Authorized Field Change

AFC G-05911

Subject: Rerouting of the Instrument Panel (IP) Harness Behind the Front Grille and Main Chassis Harness at the Transmission and Engine Crossmember to Prevent Chafing on CF 500 and CF 600 Models Built Between August 4, 2004 and August 7, 2005

Figure 1 Remove Tie Strap from Bracket

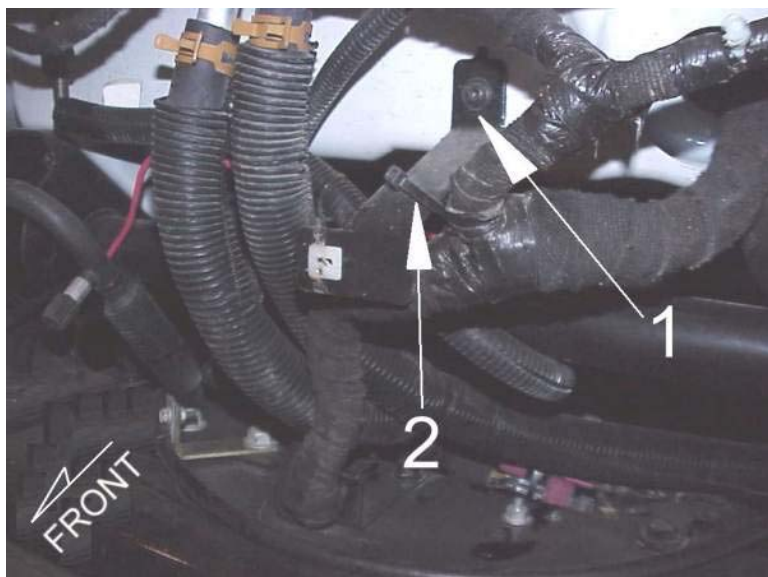
1. Remove grille mounting screw, and remove grille.
2. Remove cable strap lock securing the IP harness to grille mounting bracket (Figure 1).

Figure 2 Remove Tie Straps

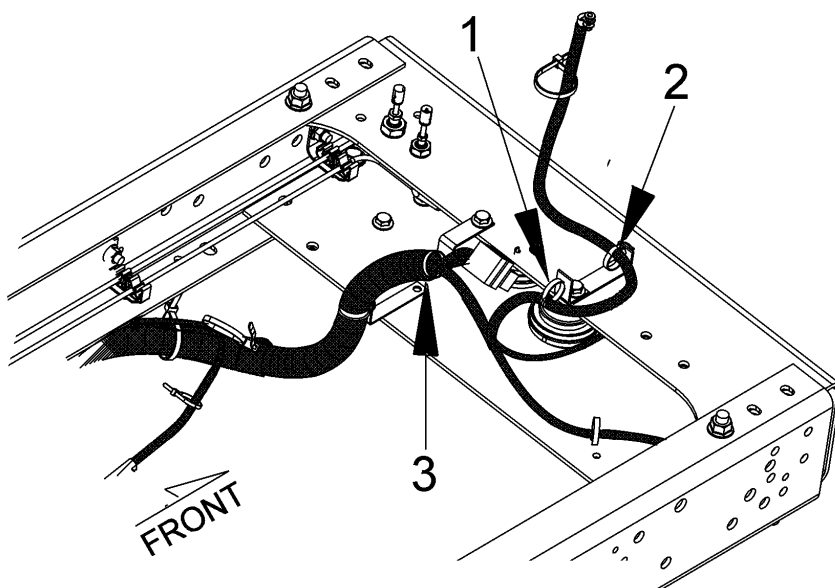
3. Remove 2 cable strap locks securing the IP harness to passenger side bracket(s) (Figure 2, Item 1 and Item 2). Remove the bracket and save fasteners for reuse during reassembly.

4. Remove cable strap lock securing the IP harness to rear of driver side bracket (Figure 2, Item 3). Remove the bracket and save fasteners for reuse during reassembly.
5. When necessary, remove other cable strap locks to allow movement of wire harness.
6. Use the original fasteners and a small P-clip to secure the harness at the point where the passenger side bracket was removed. Orient the P-clip with the loop to the rear, facing up (Figure 3, Item 2).

Figure 3 Install P-Clips

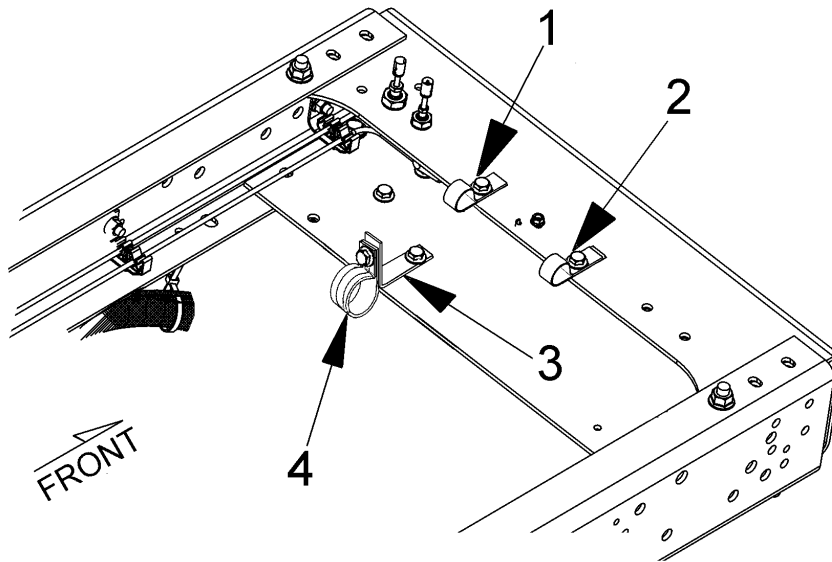
1. Small P-Clip, Drivers Side Location
 2. Small P-Clip, Passenger Side Location
 3. Existing "L" Bracket
 4. Larger P-Clip, Drivers Side Location
7. On the driver side, two P-clips (Figure 3, Item 1 and Item 4) will be installed in place of the driver side brackets using the original fasteners. The larger clip, Figure 3, Item 4, must secure the larger harness, and is fastened to the existing "L" bracket, Figure 3, Item 3, with the P-clip loop facing down. The small clip, Figure 3, Item 1, must secure the small harness and should have the loop facing up (Figure 3, Item 1, Item 2, and Item 4).
 8. With the clips in place the harness should be secured so that it runs parallel with the rear of the crossmember and clear of any interference and secure the upper leg of the harness to the cab hinge bar with a cable strap lock (Figure 4 and Figure 5).

Figure 6 Install Cushioned P-Clip Viewed from Under Chassis

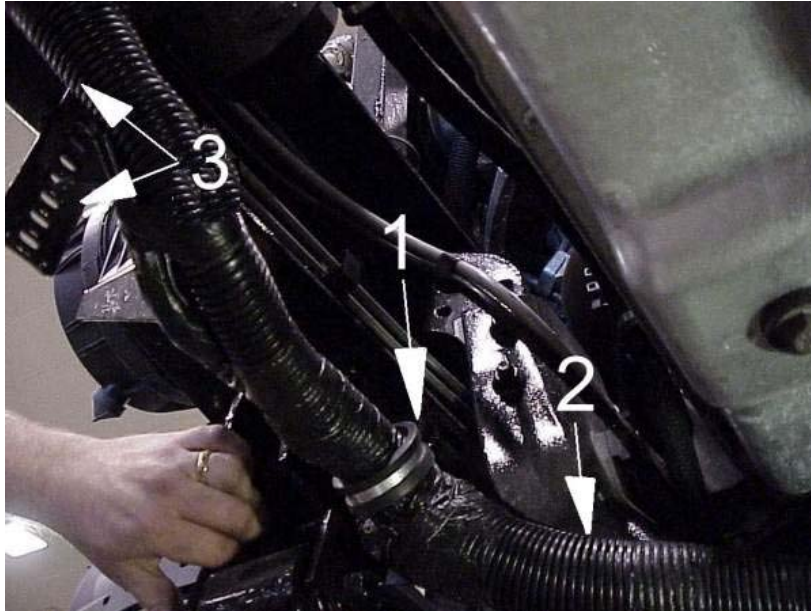
10. On the driver side frame rail behind the cab, locate and remove two (2) cable strap locks from the main chassis harness near the break out harness.
11. Remove the cable strap lock bracket near the harness break out and replace it with a cushioned P-clip.
12. Re-install the main chassis harness into the cushioned P-clip (Figure 6, Item 1), before the break out harness (Figure 7, Item 1), and tighten the fasteners .

1. Breakout Harness
13. Install a cable strap lock to the main chassis harness to the rear of the cushioned P-clip as shown in Figure 6, Item 3.
14. From under the chassis locate two (2) cable strap locks securing the main harness to the engine crossmember.
15. Remove the cable strap locks.
16. Remove the fasteners and cable strap lock brackets. Reinstall the brackets so that the bend in the bracket is facing downward (Figure 8, Item 5).

Figure 8 Revised Harness Bracket Orientation

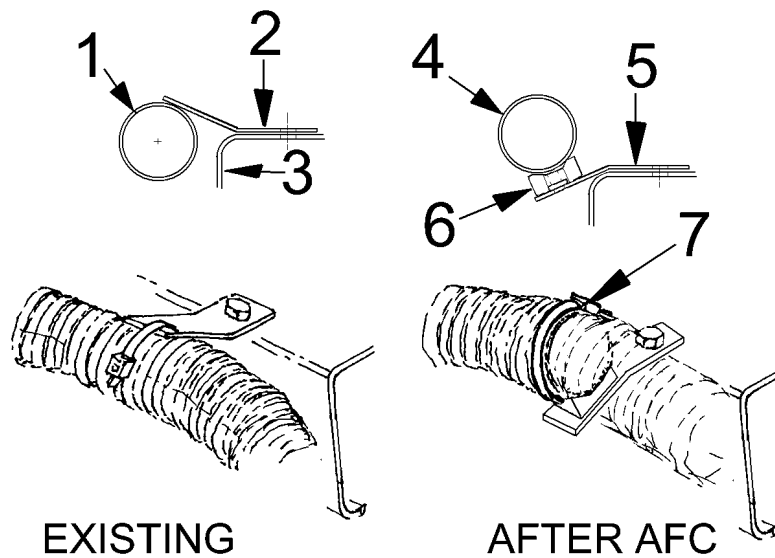
17. Install a saddle to both brackets (Figure 8, Item 6) and secure the main harness with cable strap locks (Figure 8, Item 7). When properly routed the harness should look like Figure 9.

Figure 10 Typical Harness Routing on the Passenger Side of the Engine Crossmember

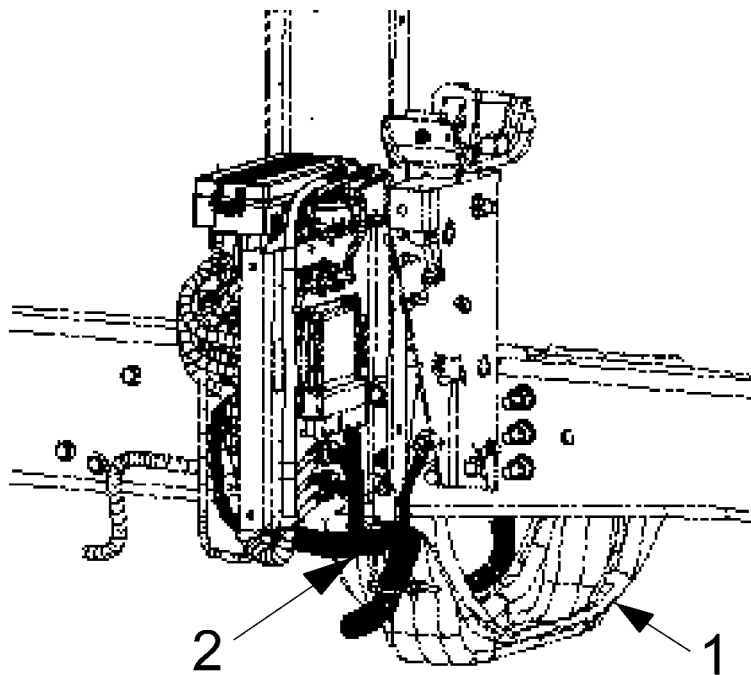
18. Follow the main harness to the passenger side to locate the third (3) cable strap lock. Note the harness, cable strap lock and bracket will be on the passenger side of the engine crossmember (Figure 10, Item 2). Remove the cable strap lock, install a saddle to the existing bracket and secure the harness (Figure 11).
